UNITED STATES PATENT AND TRADEMARK OFFICE

APPLICATION NO.	FILING DATE	FIRST NAMED INVENTOR	ATTORNEY DOCKET NO.	CONFIRMATION NO.
10/064,075	06/07/2002	Frank Poma	10539.4801	3897

## Office Action Summary

**FIG. 16****FIG. 17**

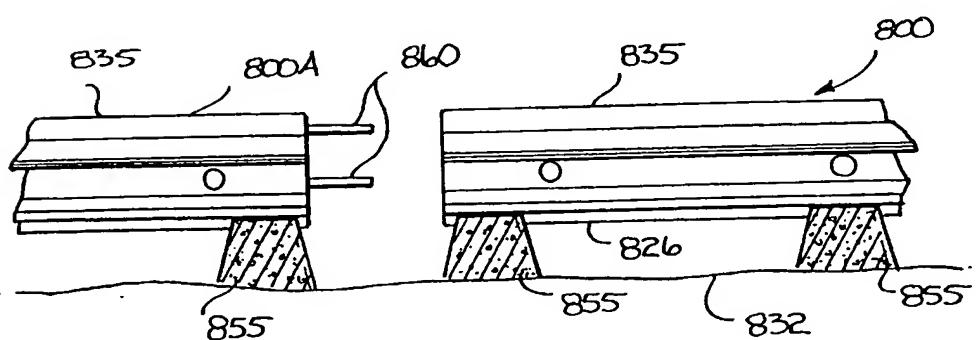
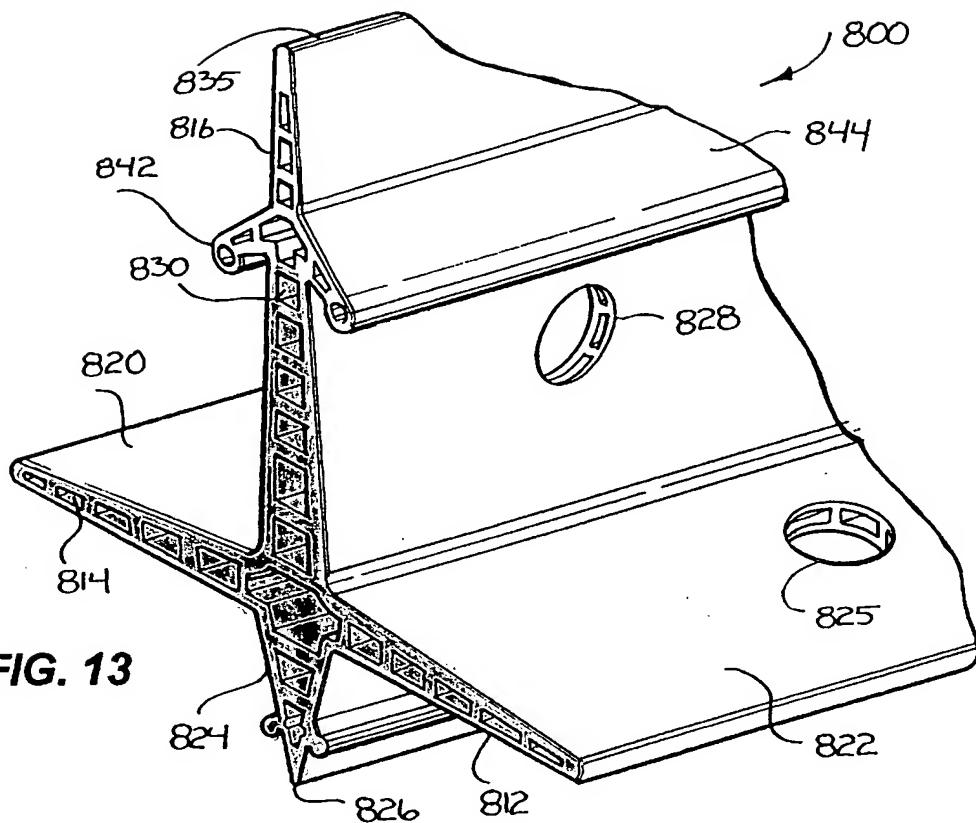
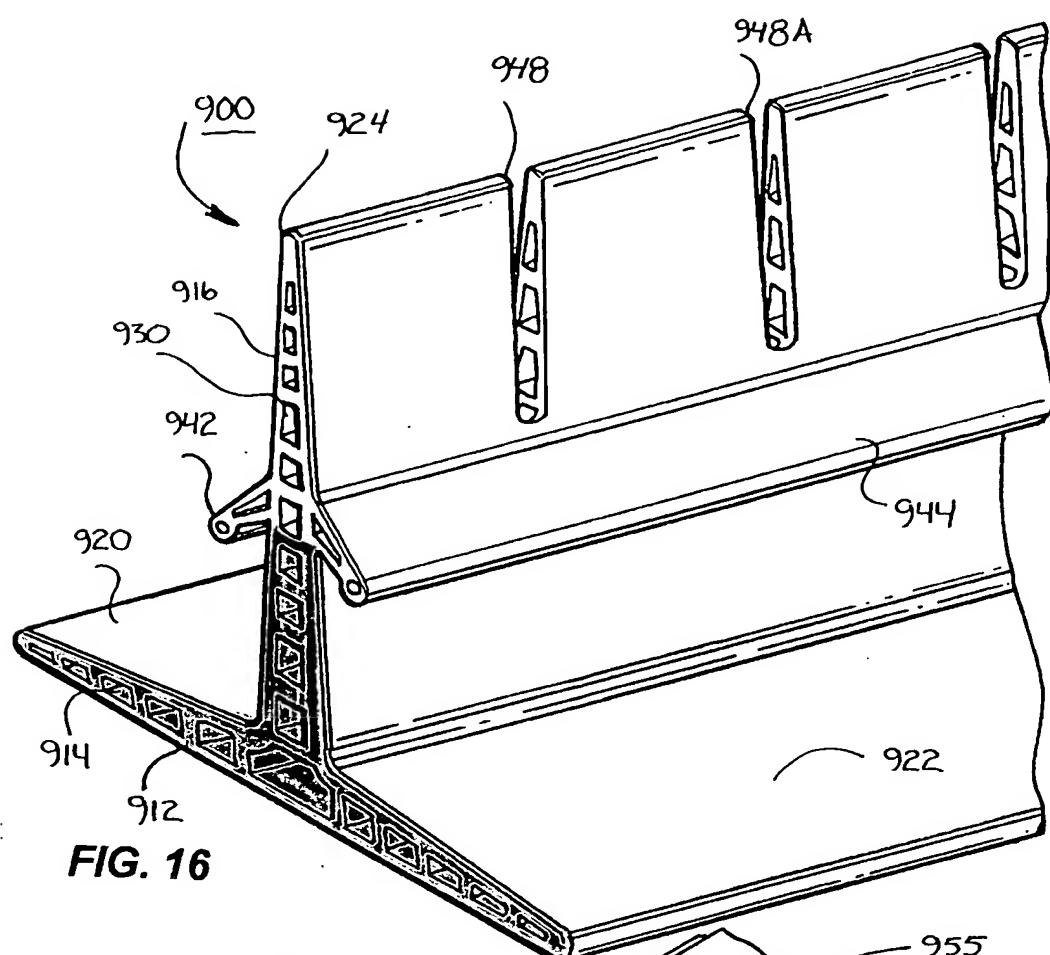
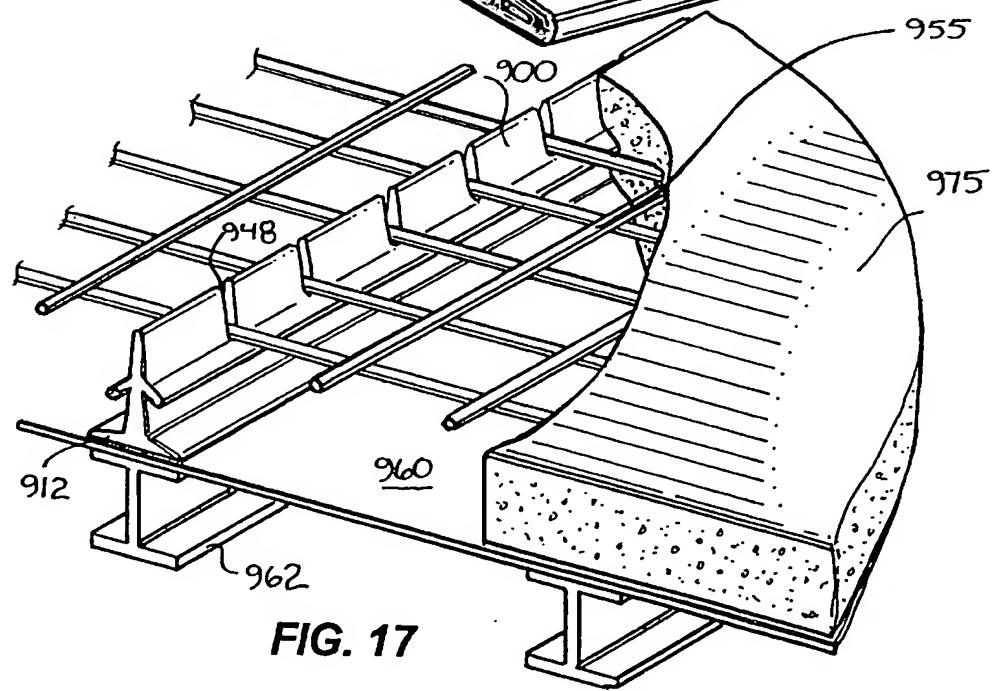
10. Claims 20-23 are rejected under 35 U.S.C. 102(b) as being anticipated by US Patent #5,956,912 to CARTER et al. CARTER et al. discloses the use of a columnar insert (800,900) including a faceted portion (844,944) and (842,942), an inner arm (816,916) and an outer T-shaped form (colored red) opposite the inner arm (816,916). Regarding claims 21-23, the faceted portion (844,944) and (842,942); inner arm (816,916) and T-shape form (colored red) are all hollow (830,930).
